Amendment and Response

Serial No.: 10/656,844

Title: RECLOSEABLE CARTON

Fig. 6

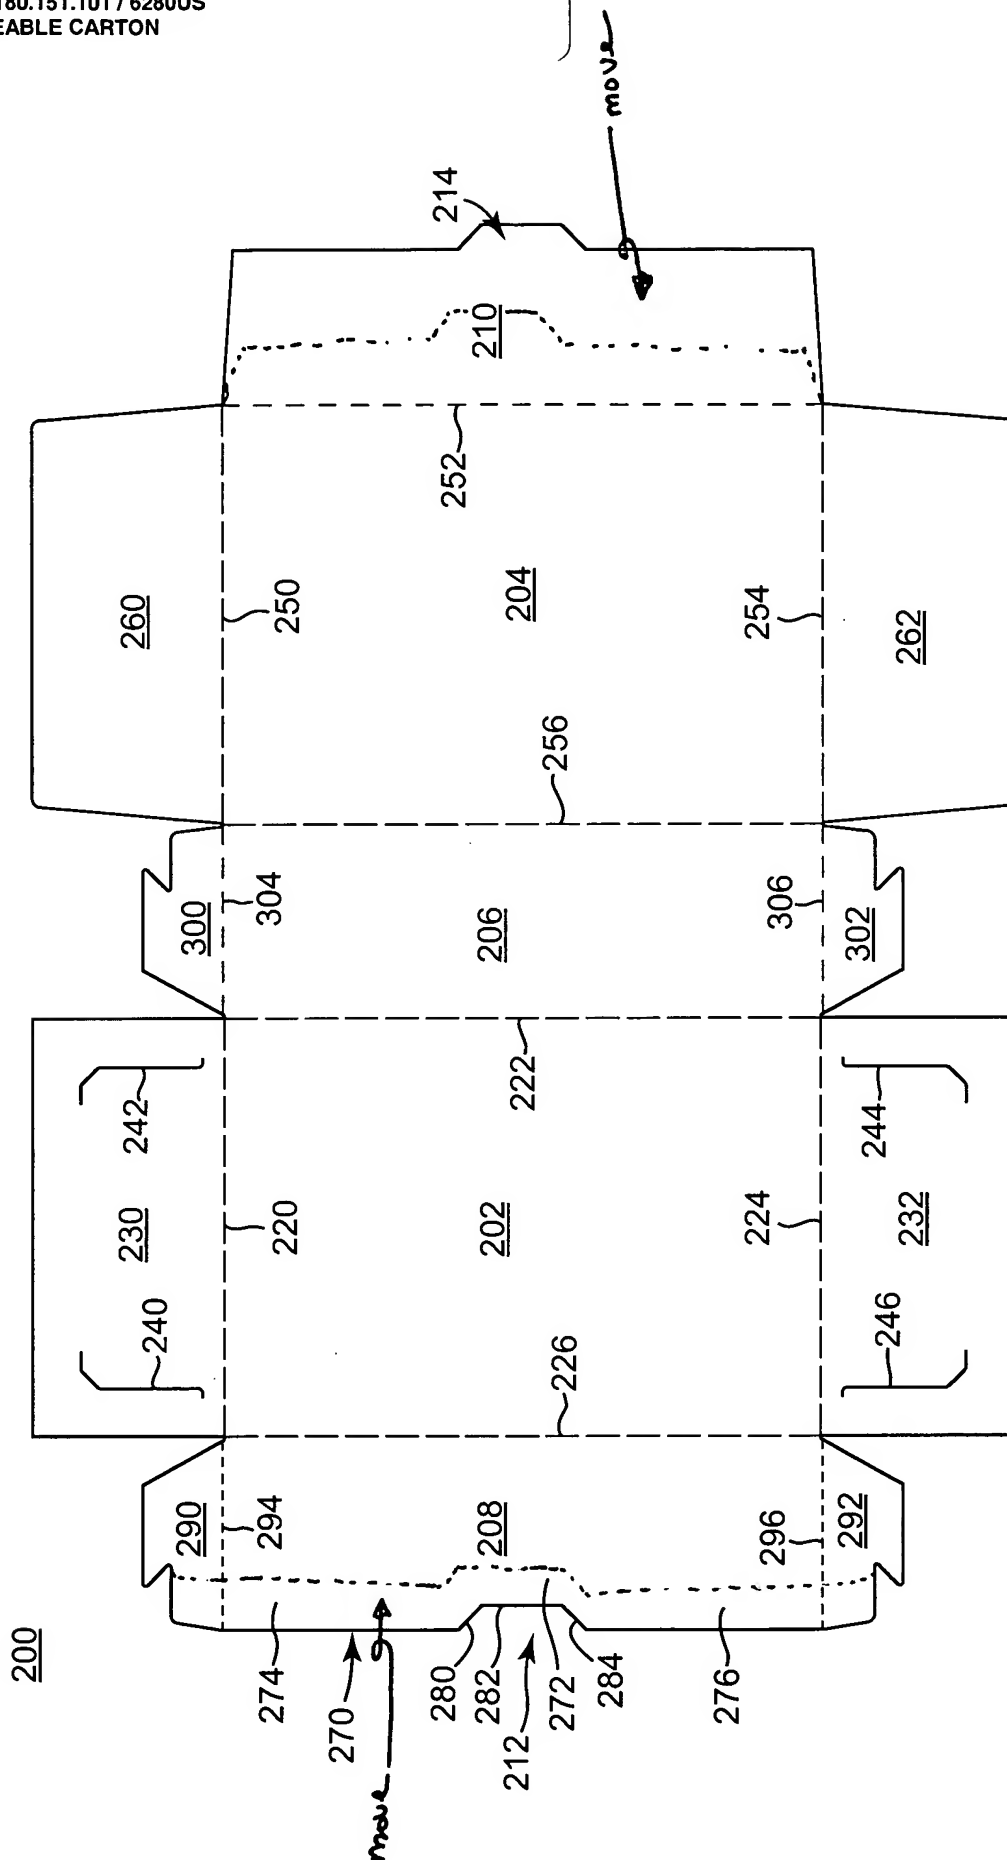
The embodiment of FIG. 6 as described on pages 12 and 13 of the specification is unclear with respect to how the tab 214 will interlock with the slot 212 when the carton is formed. It would appear that the tab 214 would be located adjacent the fold line 226 and that the slot 212 would be located adjacent the fold line 252. The specification provides no description of how the interlock and the carton formed from the blank of FIG. 6 is made.

The specification provides no description of how a box is made from the blank of FIG. 6 where the tuck slot 212 is adapted to receive the tab 214 as part of the reclosure operation.

Claims 18 and 19 also stand rejected under 35 U.S.C. §112, second paragraph, as being indefinite according to the grounds that “[c]laims 18 and 19 are unclear with respect to how the

construction as defined in these claims, i.e. the FIG. 6 embodiment[,] allows interlocking of the tab and slot.” *NFOA* at para. 6.

Please replace FIG. 6 with new FIG. 6 shown in the attached Replacement Sheet. Attachments include one Replacement Sheet including changes to FIG. 6 and one Annotated Sheet showing changes to FIG. 6 in red.

As described in greater detail below, it is believed that the exact proportions of FIG. 6 are not limiting and the changes made are supported by the specification and figures according to the understanding of one of ordinary skill in the art. As such, the proportions of FIG. 6 have been modified in an effort to further clarify the application and expedite prosecution.

With the above tenants in mind, any incongruity presented by the dimensions of FIG. 6 is at least outweighed by (1) the presumption of an adequate description; (2) the remainder of the application, including the claims, detailed description, and other figures; and (3) the understanding that FIG. 6 does not show actual proportions.

As outlined in the previous sections, the actual proportions of FIG. 6 should not be given undue weight, as FIG. 6 has never been designated as “to scale.” Furthermore, the “content of the application disclosure” includes description and figures demonstrating how a tuck slot can be adapted to selectively receive a tab. In this manner, the application disclosure is sufficient to ensure the scope of the claims (1) is clear so that the public can be informed to the boundaries of what constitutes infringement of the patent and (2) provides a clear measure of what Applicant regards as the invention. This conclusion is further buttressed by the guidance of the Federal Circuit that one of ordinary skill would view FIG. 6 as not showing exact proportions. Furthermore, the prior art could be relied upon to some extent to gain a general overall understanding of how tabs and tuck slots interact and what complementary carton proportions might be required to allow such interaction.
